APPLICATION NO.	FILING DATE	FIRST NAMED INVENTOR	ATTORNEY DOCKET NO.	CONFIRMATION NO.
10/648,305	08/27/2003	Klaus Junker	1415 US	3682

Office Action Summary

DETAILED ACTION

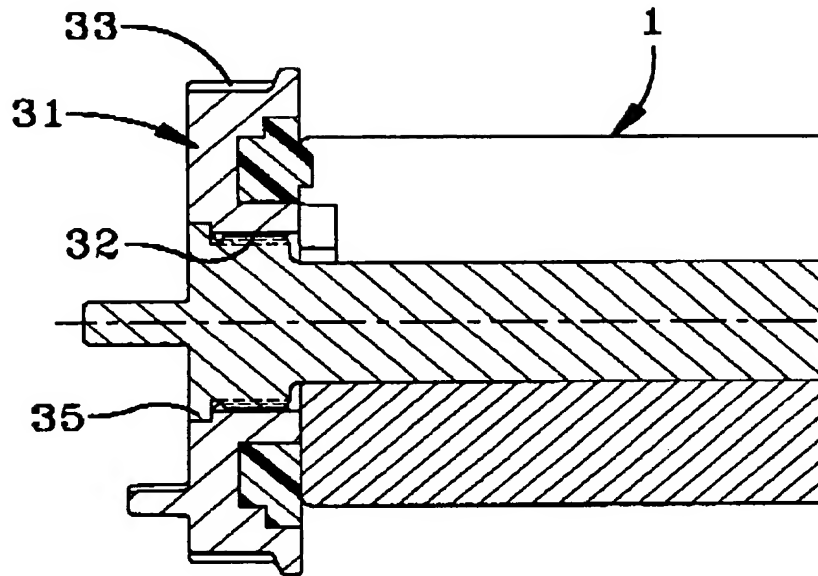
4. Applicant's arguments filed 3/23/06 have been fully considered but they are not persuasive. The applicant argues: "Claim 1 as amended recites the circumferential groove (5) extends into the bar material more deeply in a radial direction than the gear. Furthermore, this is as is shown in each of figures 1,4, and 5-10. More particularly, the

tool 10 in figure 9 shows the projection 12 which forms the groove 5 on the gear 2 clearly extending much deeper radially inwardly than the gear teeth to form a circumferential groove having a side boundary surface on the flange and a side boundary surface adjacent to and radially deeper than the gear. Bell et al. show in figure 2 a torsion bar wherein the gear teeth project outward from the torsion bar and the space between the flange 35 and the gear is not shown deeper than the gear teeth. As a result the alleged groove, if such a space could be considered a groove, does not have a side boundary surface adjacent to or radially deeper than the gear.” Bell Figure 2, and Applicant's Figure 6 have been included below for convenience.

Bell et al. Figure 2

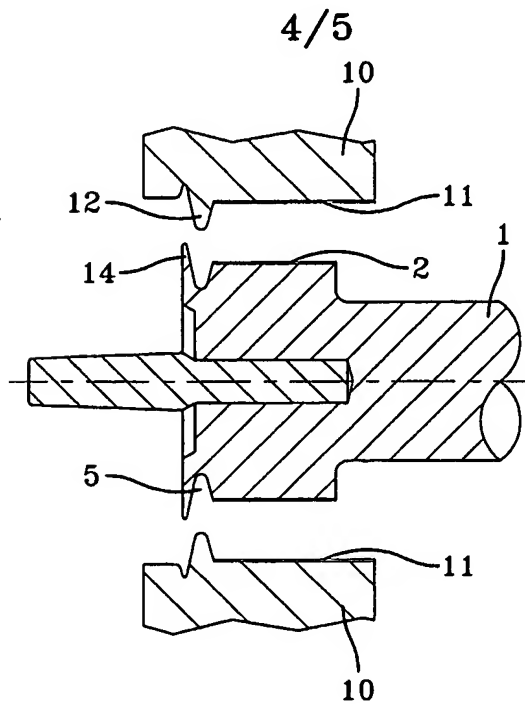
Bell et al. figure 2 clearly shows a long narrow circumferential channel between flange (35) and the gear teeth (32) shown in cross section. This groove, as shown in Figure 2, extends into the torsion bar more deeply in a radial direction than the adjacent gear crest. Furthermore, the circumferential groove has a side boundary surface on the flange and a side boundary surface adjacent to and radially deeper than the gear (as best understood) as can be seen in figure 2.

Because the groove between the flange (35) and the gear teeth (32) is defined by; a sidewall comprised of the flange (35) itself, a lower portion comprised of the torsion bar itself, and a radially higher adjacent sidewall comprised of a radially lower

portion of the gear (as best understood), the groove is considered by the examiner to extend into the torsion bar more deeply in a radial direction than the adjacent gear (as best understood) and has a side boundary surface on the flange and a side boundary surface adjacent to and radially deeper than the gear (as best understood).

In response, the groove, having a side wall comprised of a radially lower portion of the gear, is clearly shown deeper than the radially higher crests of the gear teeth and therefore is also considered by the examiner to be radially deeper than the gear (as best understood).
